# UNITED STATES PATENT AND TRADEMARK OFFICE

<b>Office Action Summary</b>	<b>Application No.</b> 09/733,302	<b>Applicant(s)</b> COHEN ET AL.	
	<b>Examiner</b> Anu Ramana	<b>Art Unit</b> 3775

## **DETAILED ACTION**

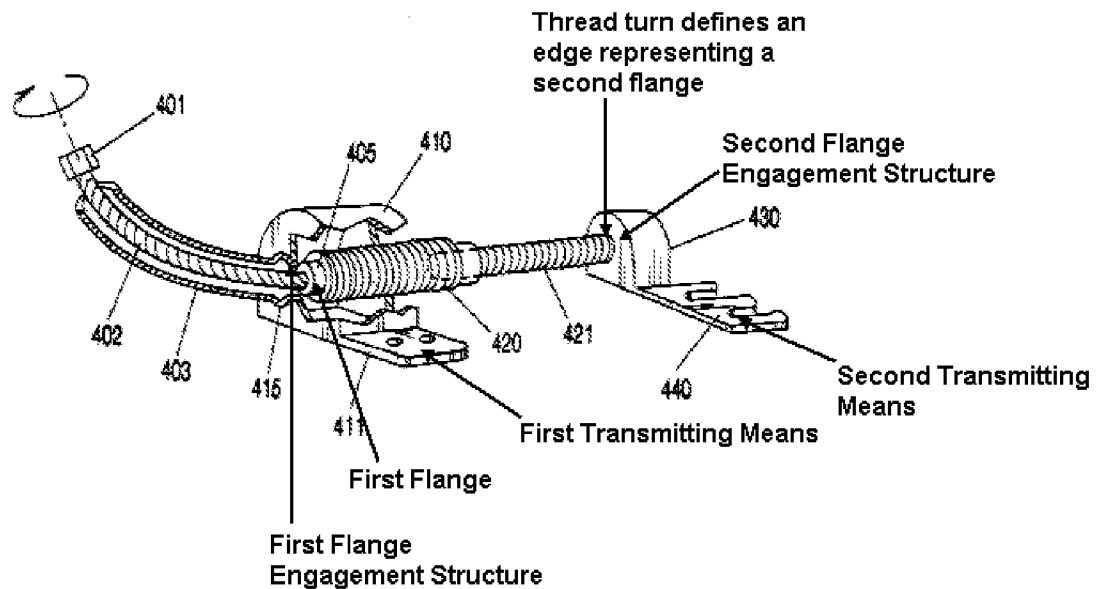
Applicant's arguments with respect to the rejections over Landsberger are not persuasive for the following reasons. As illustrated in marked up Fig. 4B on the following page, Landsberger discloses the first transmitting means to have a first flange engagement structure, the second transmitting means to have a second flange engagement structure, and the expansion means to have a first flange 405 that

engages the first flange engagement structure and a second flange that engages the second flange engagement structure.

Landsberger also discloses that the flexible shaft and the flexible sheath are removed after distraction is complete (col. 18, lines 26-29). Thus, the rejections under 35 USC 102(e) over Landsberger are deemed proper.
